# 477 9th Avenue

Five-Story Office/Residential  
Mixed-Use Development  
(PA-2022-004)

Planning Commission Study Session  
May 24, 2022

Linda Ly, Associate Planner  
Community Development Department

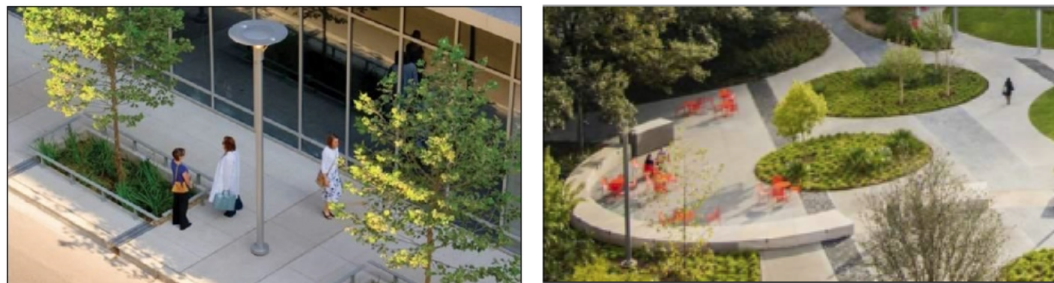
1. What design treatments and/or modifications to the overall building mass and scale should the applicant consider to improve its relationship to the lower scale surrounding context?
2. Are there any suggested design revisions for the elevation facing the railroad tracks? Is this a façade that could be improved with public art or other elements?

## Proposed Sidewalk 12'

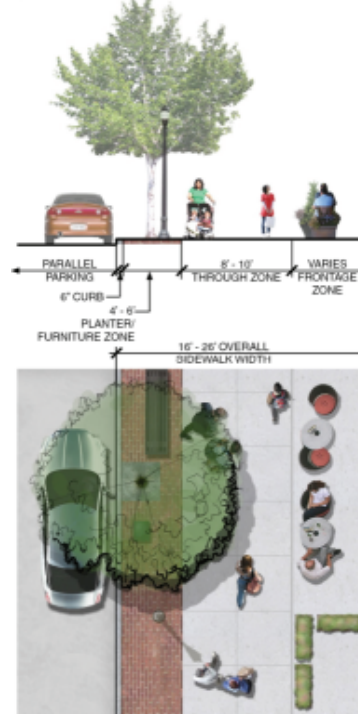
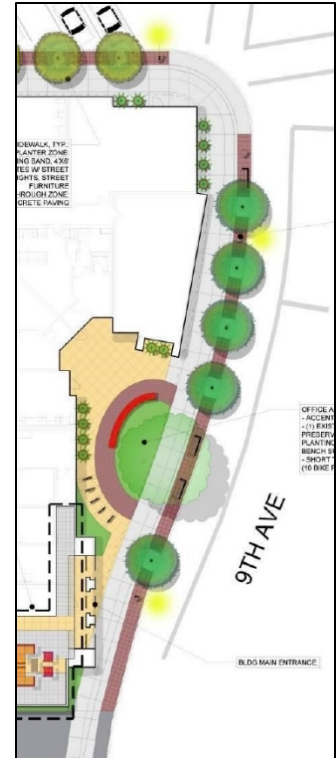
- Building Design
- **Site Plan and Landscape**
- Other
- Transition to the Downtown Retail Core
- Public Plaza
- At-grade open space
- Pedestrian Master Plan
